Inspection Photos

API: 071-09920

Operator: TWIN BRIDGES RESOURCES LLC

Inspection Date: 5/31/2022

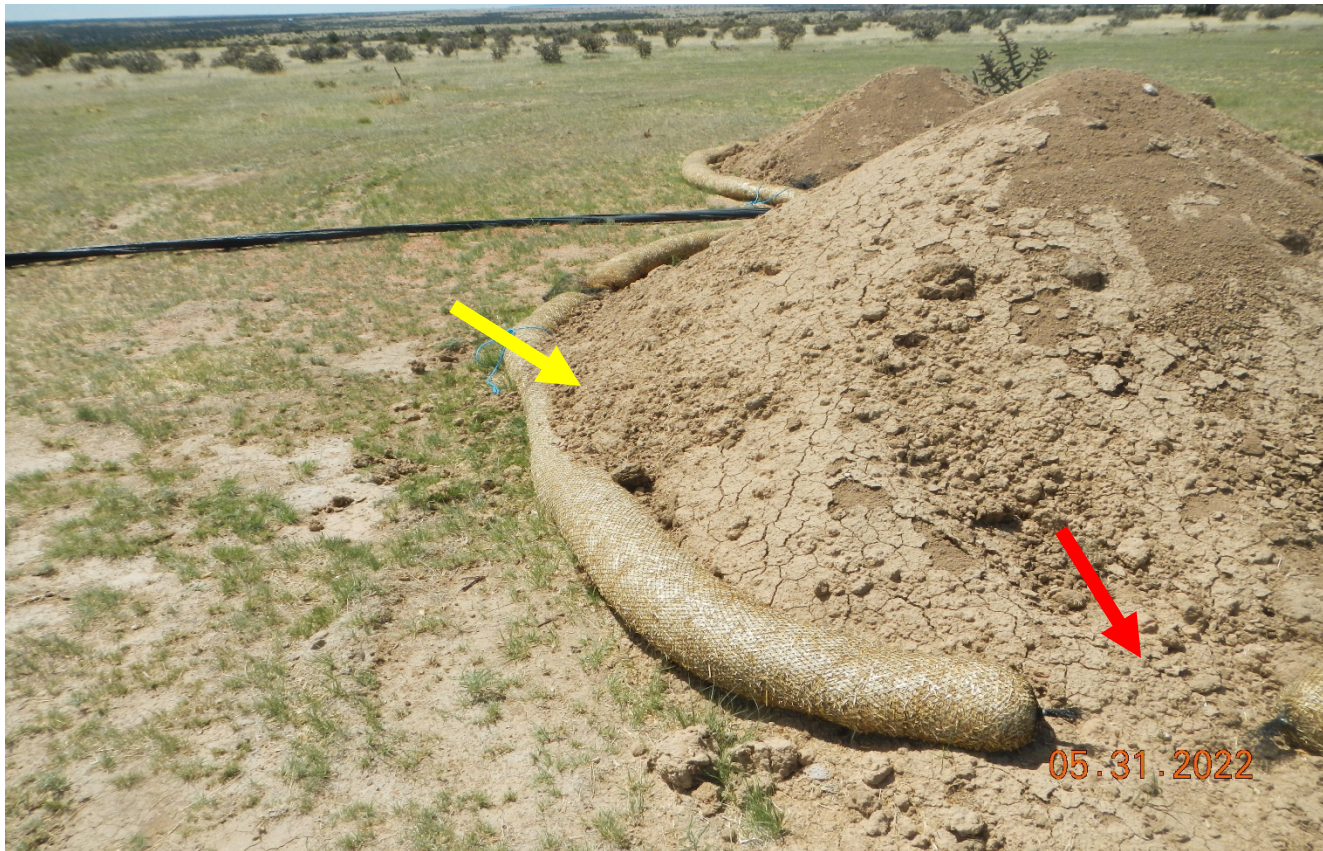
Photo 5. The straw wattles around the soil pile are not properly staked down. Soils is overtopping the wattles shown at yellow arrow and there is a space between the wattles at red arrow. Stormwater controls need to be installed per good engineering practice.
